BOARD MEETING

AGENDA

WEDNESDAY, APRIL 2, 2025
2:00 PM

Subdivision, land development, and municipal proposals require review and comment by the BCPC, as authorized by the Pennsylvania Municipalities Code (Act 247, as amended). This month's activity includes the following:

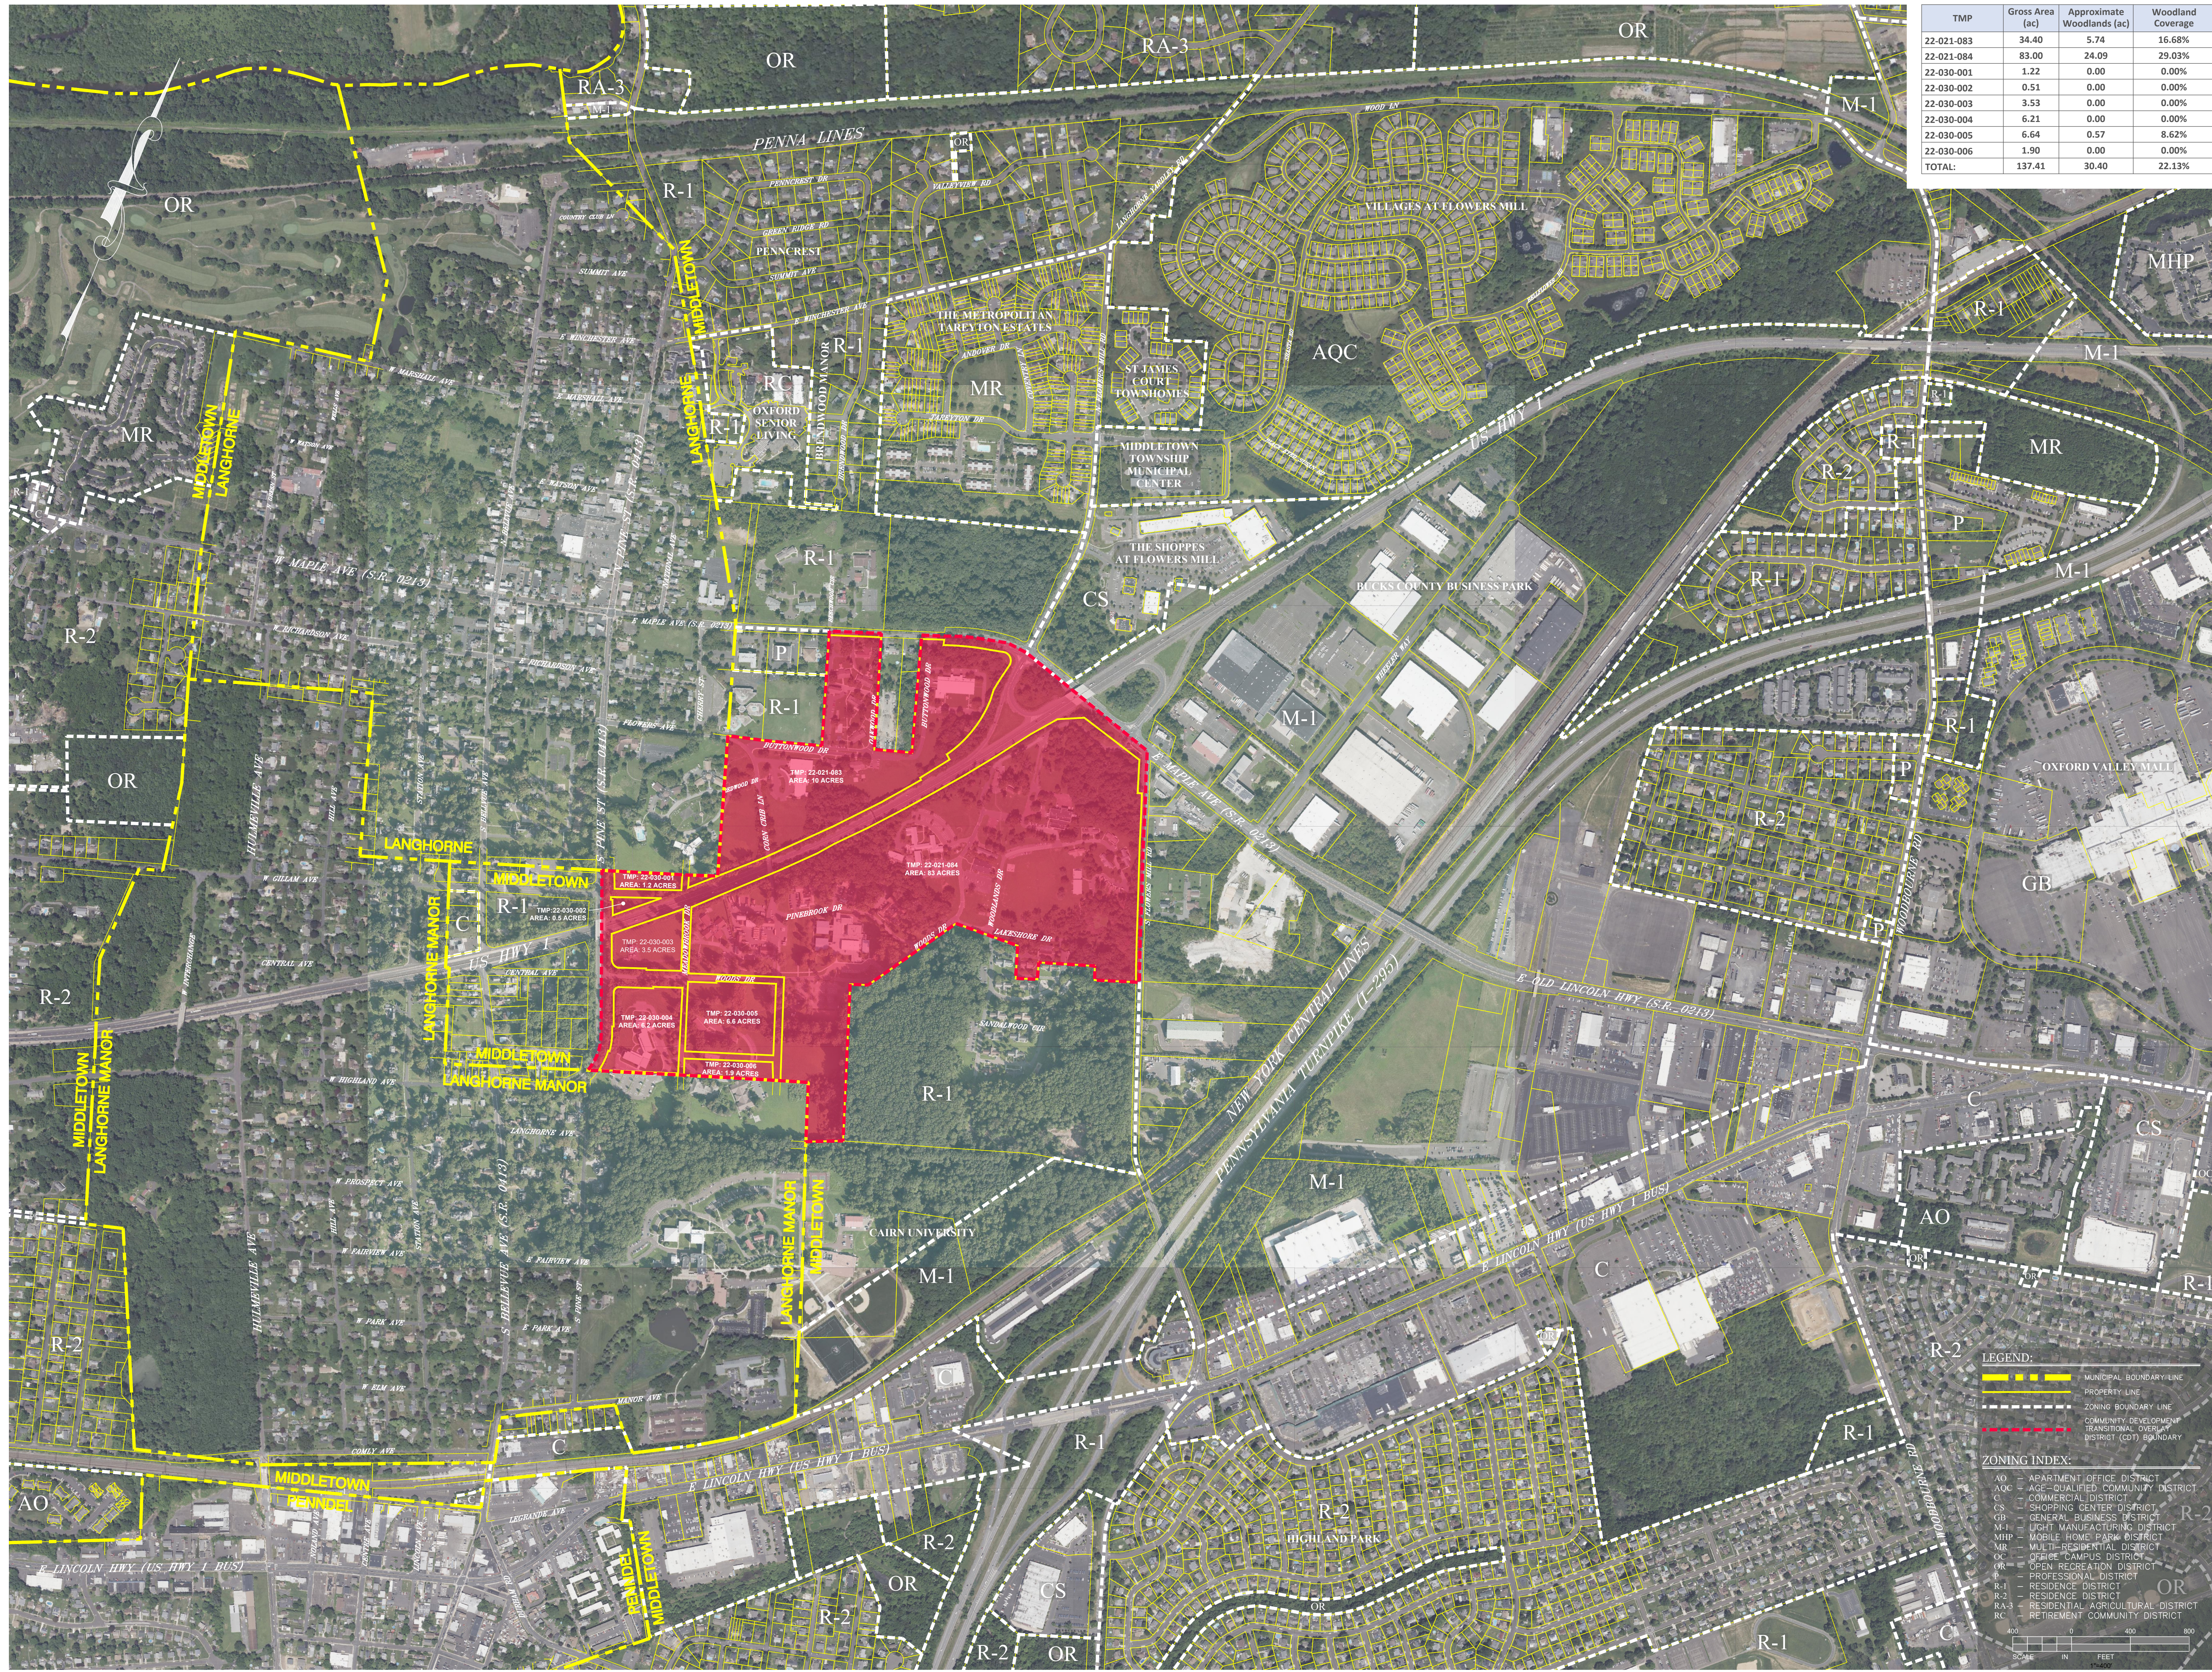
1. **Comprehensive plan**—The proposed amendment of the zoning map is not consistent with the future land use plan in the township's comprehensive plan (*Middletown Township Comprehensive Plan Update* (2020)). The comprehensive plan notes that the "zoning map approximates Middletown's current vision of future land use" (pg. 13). The overlay district proposes nonresidential uses, such as medical offices and retail stores, where the township's comprehensive plan identifies future land use for the site for uses permitted in the R-1 Residence

If the township permits the type of development allowed by the CDT Overlay District, we recommend that the comprehensive plan and future land use plan be amended to reflect this amended policy.

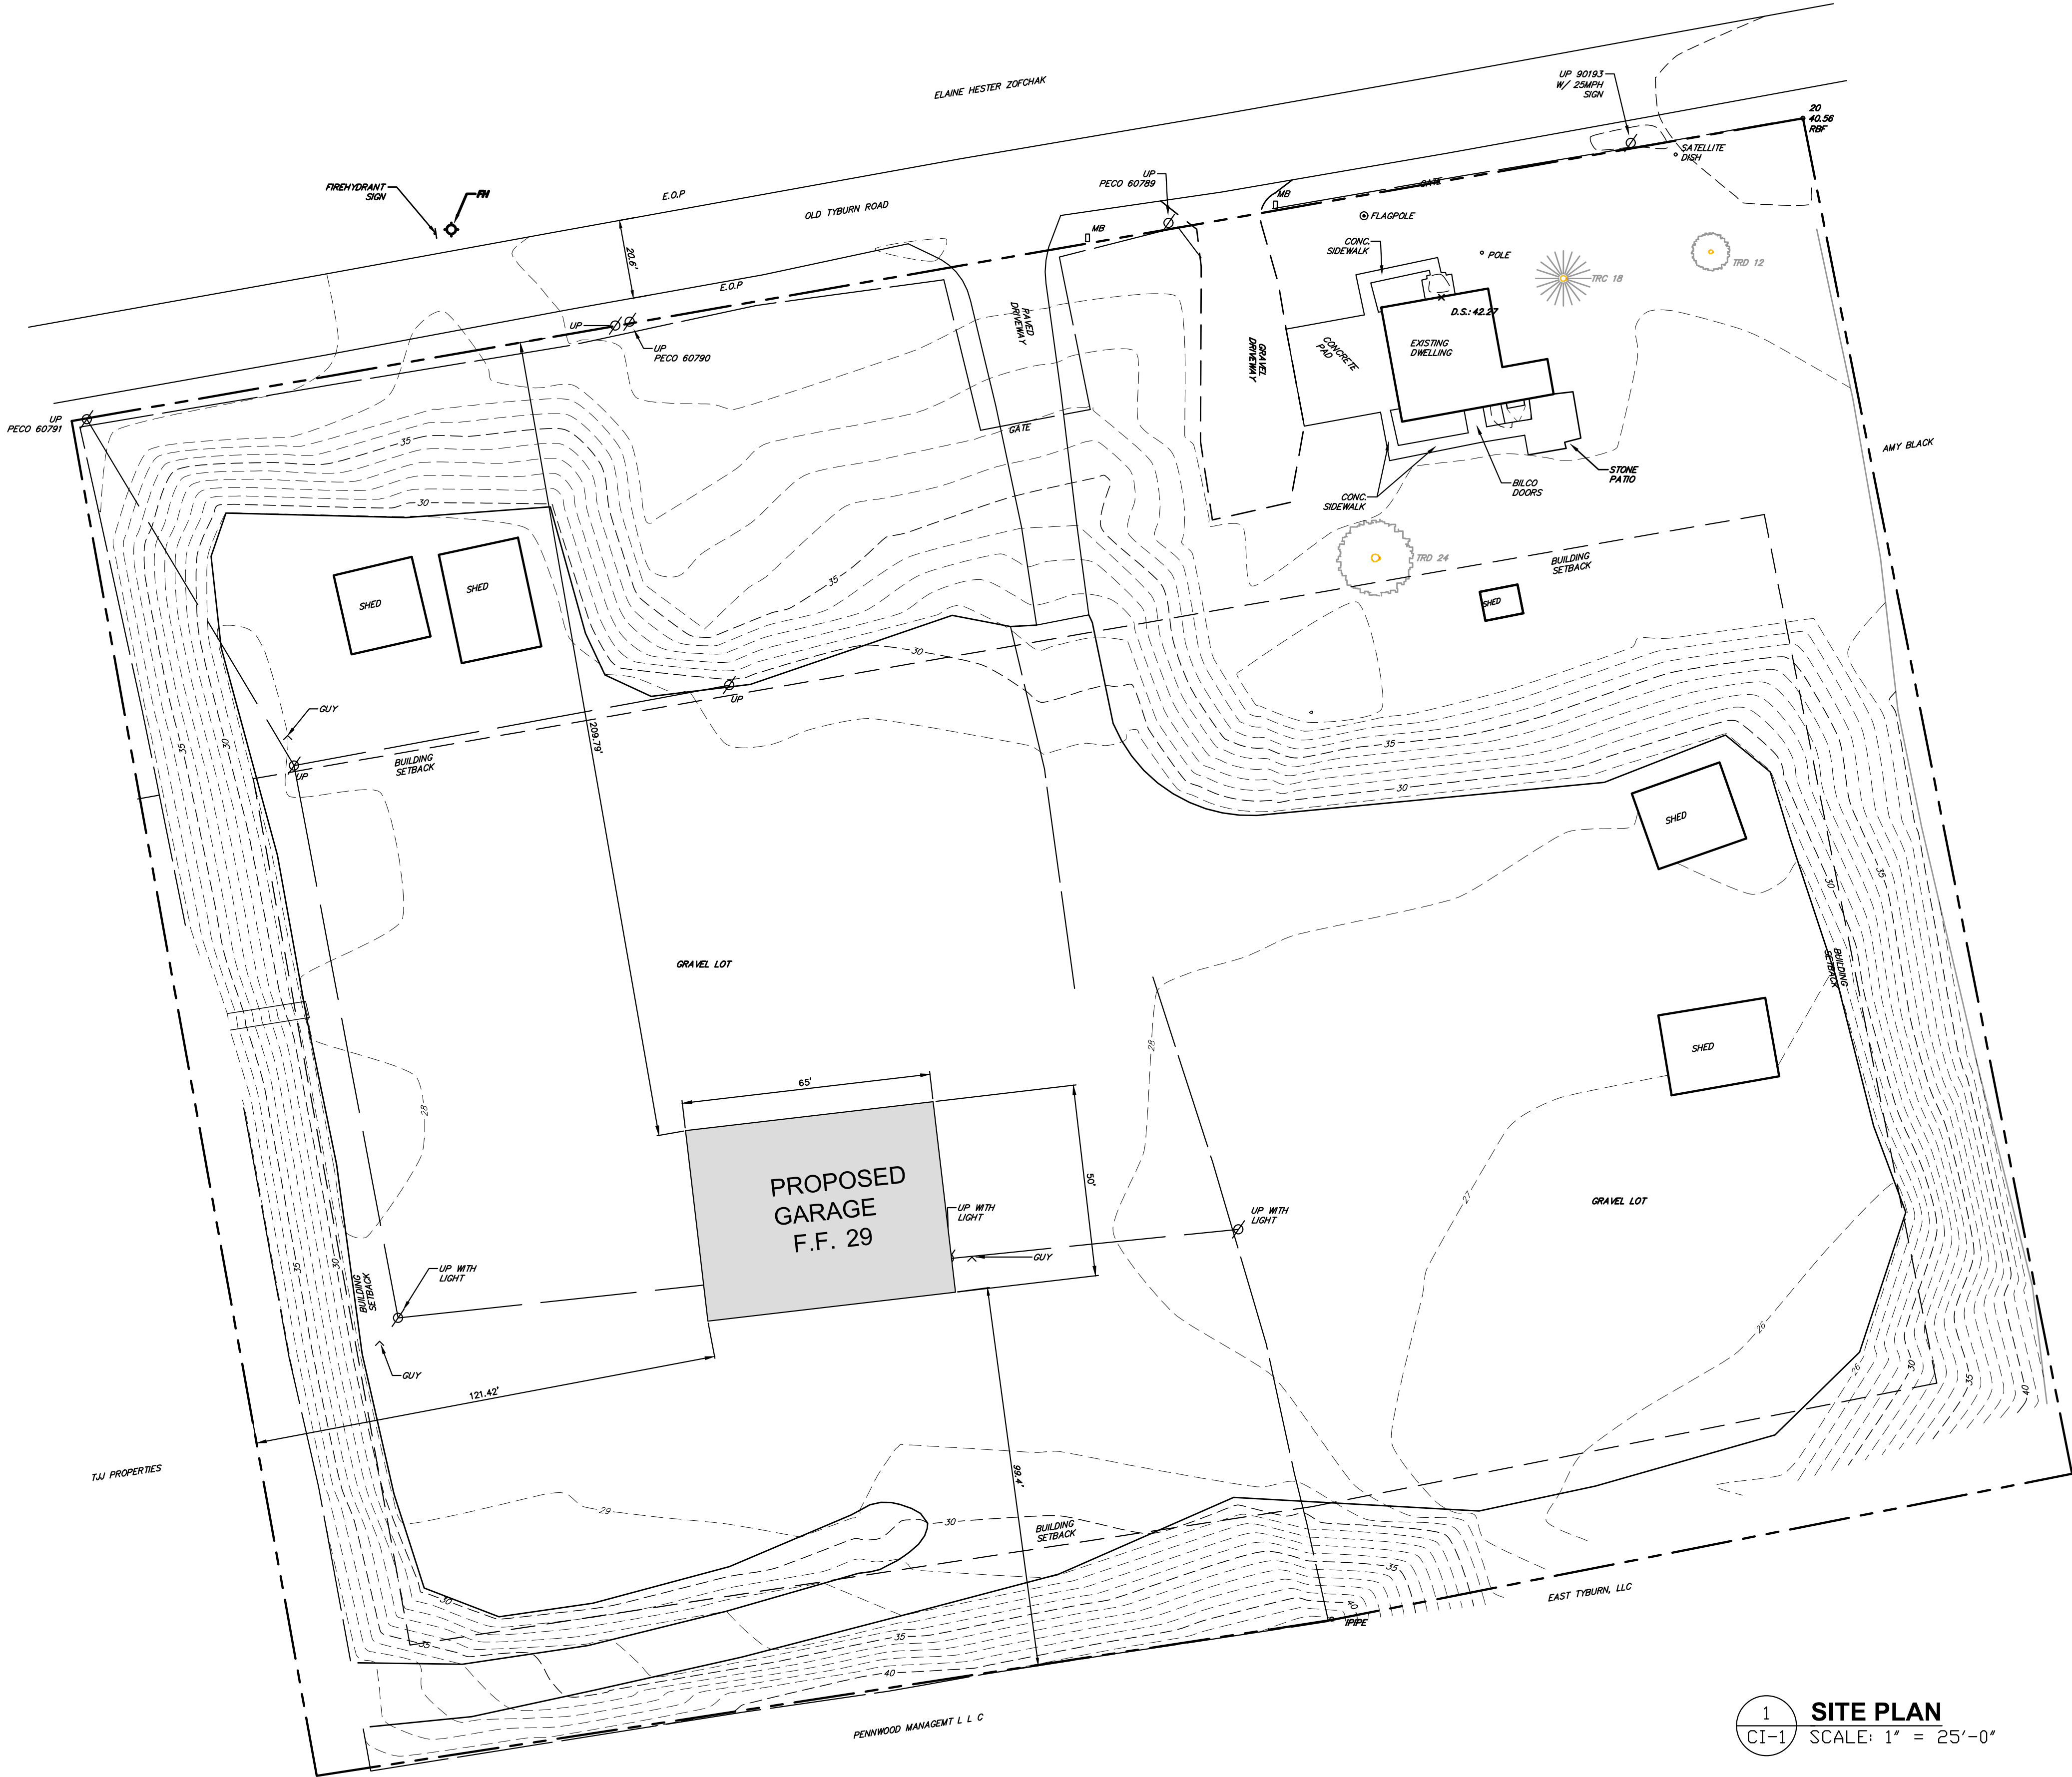
Property use and zoning—We note that the property has a single detached residence which is a nonconforming use in the Heavy Industrial-A zoning district. The proposed use is a garage related to

the commercial use of the property. We recommend that the township determine the principal use of the property and whether the proposed accessory commercial garage is permitted.

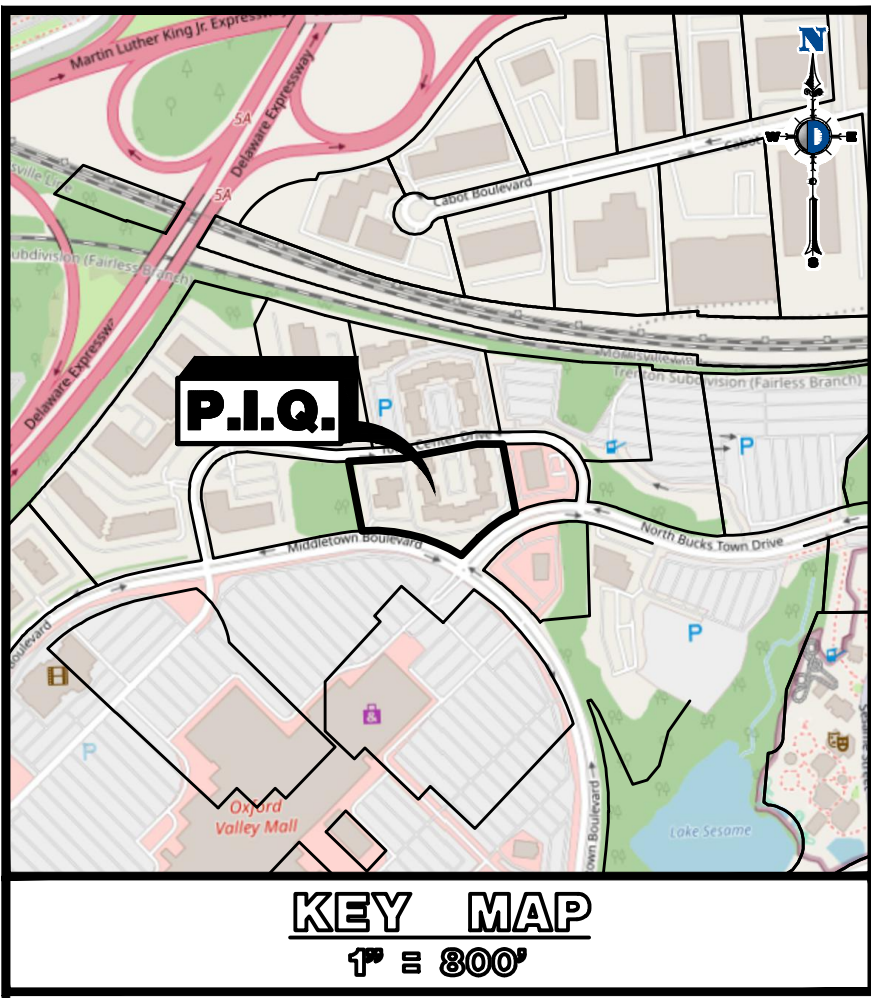
Shared driveways—The plan does not indicate that there are access easements for the shared driveways between the lots. We recommend that the applicant provides a mechanism to ensure that access between the lots is preserved and that maintenance responsibilities are defined for the shared driveways on the site, as it is likely the two lots will have different owners.
